This document was prepared by Yong Kim and Geoff Garner.

May 12, 2011

*Change the Text of 2., as shown*

##### **10.3.14.2 State diagram**

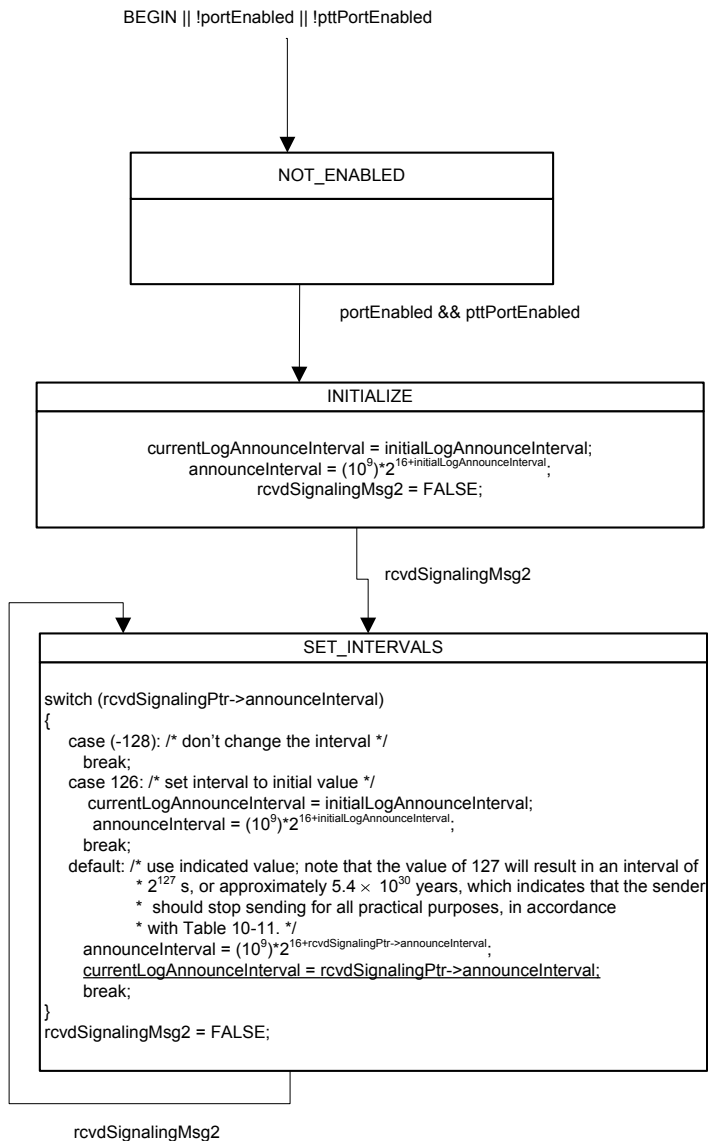
*Change the Figure of 10-16, as shown*

#### **11.2.17.2 State Diagram**

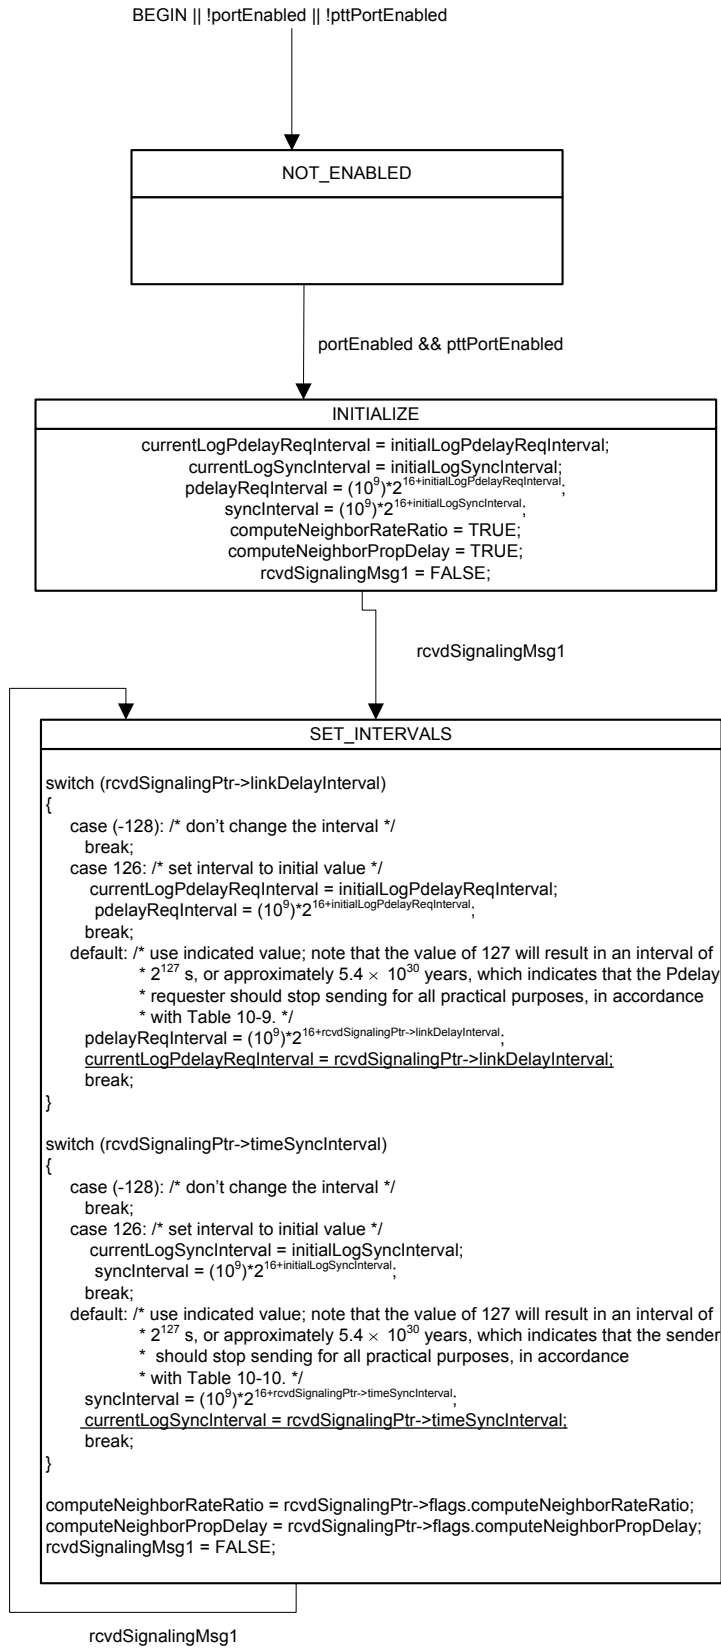
*Change the Figure of 11-10, as shown*
